# UNITED STATES PATENT AND TRADEMARK OFFICE

APPLICATION NO.	FILING DATE	FIRST NAMED INVENTOR	ATTORNEY DOCKET NO.	CONFIRMATION NO.
10/686,655	10/17/2003	Wen-Hai Tsao		1768

<b>Office Action Summary</b>	<b>Application No.</b> 10/686,655	<b>Applicant(s)</b> TSAO, WEN-HAI	
	<b>Examiner</b> George Nguyen	<b>Art Unit</b> 3723

### DETAILED ACTION

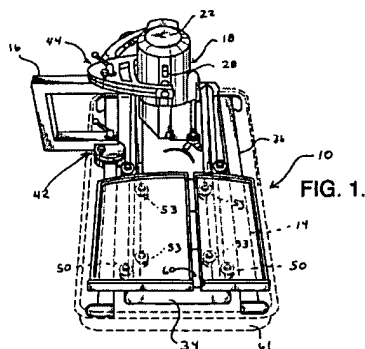
1. The specification is objected to as failing to provide proper antecedent basis for the claimed subject matter. See 37 CFR 1.75(d)(1) and MPEP § 608.01(o). Correction of the following is required: the limitations of “a second protrudent screw hole on the other side” is not clearly described in the specification. Is the tubular screw hole 53 considered the second protrudent screw hole?.

With reference to Figure 2, Sigetich et al.'4,428,159 discloses portable, direct drive abrasive saw having a saw support 21 at the end of frame 13 adjacent end member 15b.

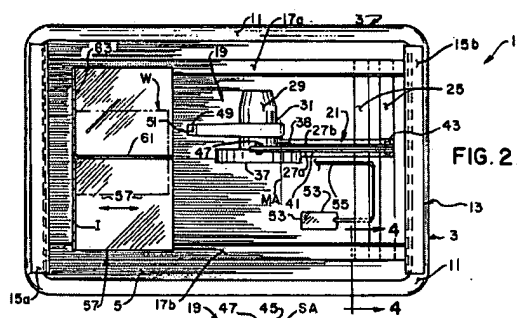
Further, portable saw 1 of the present invention includes a unitary, direct drive, rotary saw assembly, as generally indicated at 19, fixedly positioned by frame 13. The frame includes a saw support, as generally indicated at 21, at the end of the frame adjacent end member 15b. Saw support 21 is shown to comprise a pair of vertical supports 23 spaced apart from one another and at each side of the frame secured (e.g., welded) to respective rail members 17a, 17b and extending vertically above the upper edge of the vertical flange of the rail members. Horizontal support members 25 extend transversely of the frame from the upper end of one vertical support member 23 to the upper end of a corresponding vertical support member on the opposite side of the frame. Again, vertical members 23 and horizontal members 25 are of angle iron construction and the horizontal transverse members 25 are oriented so as to have their upper flanges in generally horizontal position and vertical flanges extending downwardly with the horizontal upper flanges constituting a generally planar mounting surface.

However, the prior art of record fails to provide or suggest the specific limitations of the specific limitations of "said second outer longitudinal bar ... on the other side" in the combination as claimed in claim 1.
